**REMARKS**

AMENDMENT UNDER 37 C.F.R. § 1.116  
U.S. Appln. No. 09/759,339

FIG. 2

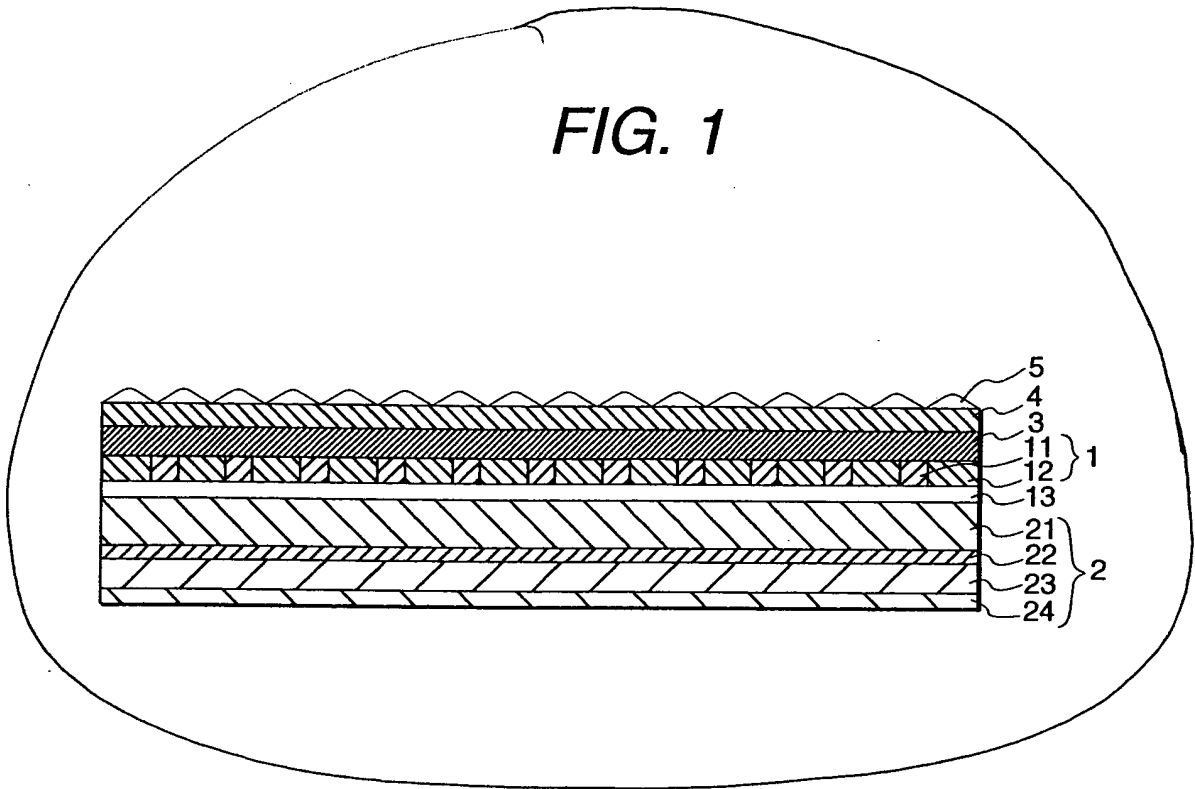
The proposed drawing correction filed on April 15, 2003 has been disapproved because the Examiner asserts that new matter is introduced into the drawings. The Examiner states that the original disclosure does not support the showing of "the optical element (3) on top of the optical element (4) as shown in Fig. 2". As can be seen in Fig. 1, these elements are reversed.

The drawings filed on January 16, 2001 and April 15, 2003 are also objected to by the Draftsperson for informalities as indicated in the "Notice of Draftsperson's Patent Drawing Review", PTO-948.

Applicants note that the LCD in Fig. 2 is labeled as "3" which may be confusing to the Examiner who may be confusing the LCD (3) with one of the "optical parts 3, 4, and 5" in Fig. 1. Applicants amend Fig. 2 to label the LCD with new label "6" to clarify the drawing and to overcome the Examiner's objection. The LCD (6) of Fig. 2 is appropriately depicted on top of optical part (4). Support in the specification can be found, for example, at pages 26-27 describing that the organic EL device may contain one optical part or two or more optical parts where such optical part(s) may be disposed in one or more appropriate positions outside or

Additionally, Applicants modify Fig. 2 to clarify that an optical part 3 may exist below the optical element 4.

Applicants also submit replacement sheets for Figs. 1 and 2 to overcome the Draftsperson's objections that the scale of the drawings is too crowded and that the numbers are not uniformly thick and well-defined. These replacement sheets for Figs. 1 and 2 substitute for the previously filed drawings.
